Product change notification (PCN)

Title / short description	New Tooling with optimized design for injection molding
Affected article category	PCB terminal blocks and PCB connectors
Change category	Form and appearance
Change number	CAA230054-08
Reason for PCN/PDN Revision	Creation

Change of the inner PCB terminal block geometries for optimization of injection molding process.

Product Changes in comparison – Pitch 3,5

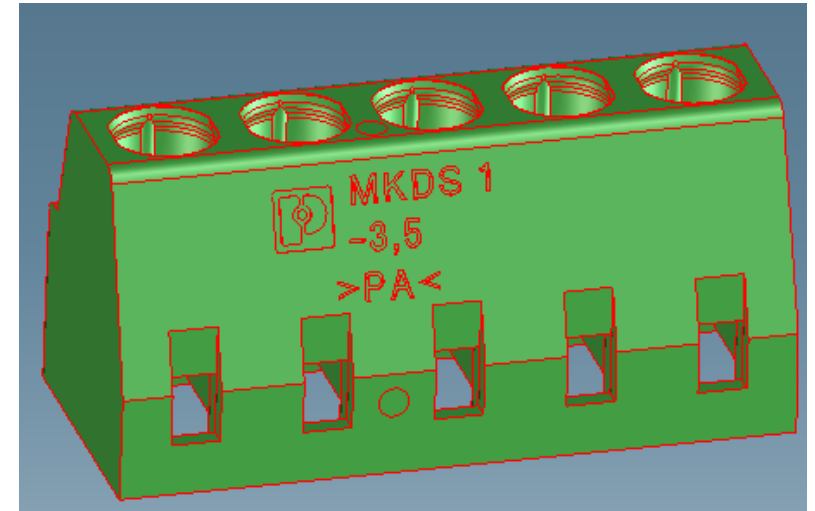
- Labeling in future centered instead of one-sided
- Side walls 0.5° conical
- New imprint on top of the housing

Product Changes in comparison – Pitch 3,81

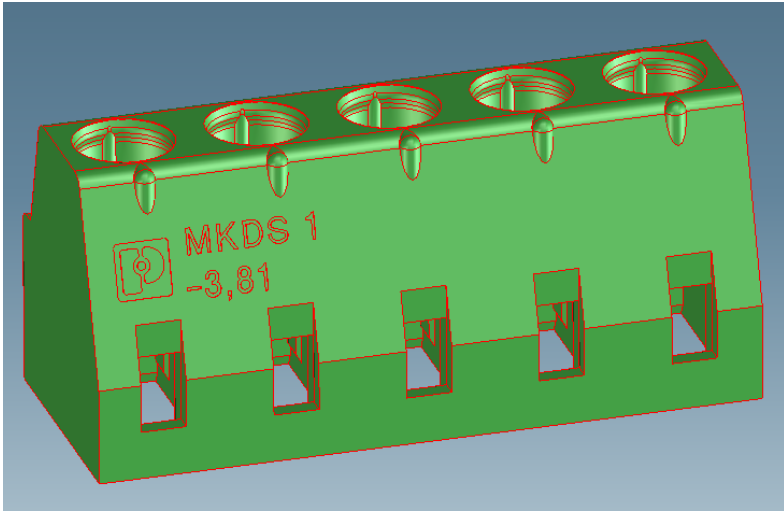
- Labeling in future centered instead of one-sided
- Side walls 0.5° conical
- New imprint on top of the housing

- Screw shaft with surface
- Recognition wart -3.81 offset

- Insertion chamfers in the area of the terminal sleeves
